CERTIFICATE OF APPROPRIATENESS

Property: 8111 De Leon St, Lot 10, Block 62, Glenbrook Valley Section 11 Subdivision. The property includes a historic 3,246 square foot one-story single family residence situated on a 12,065 square foot interior lot.

Proposal: Alteration—Applicant proposes two changes to the exterior of the home:

Existing Front Door

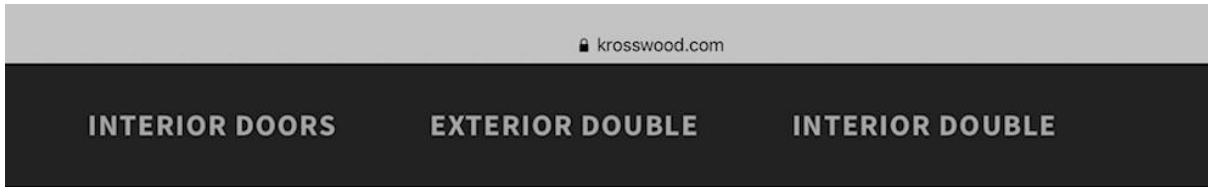
<i>The door and two side lite replacements are compatible with design of a 1960 Traditional Ranch style home.</i> |

<i>The door and two side lite replacements are compatible with design of a 1960 Traditional Ranch style home</i> |

<i>The door and two side lite replacements are compatible with design of a 1960 Traditional Ranch style home</i> |

Recommendation: Partial Approval: Staff recommends approval of the front door and two side lites; staff does not recommend approval on the painting of unpainted masonry.
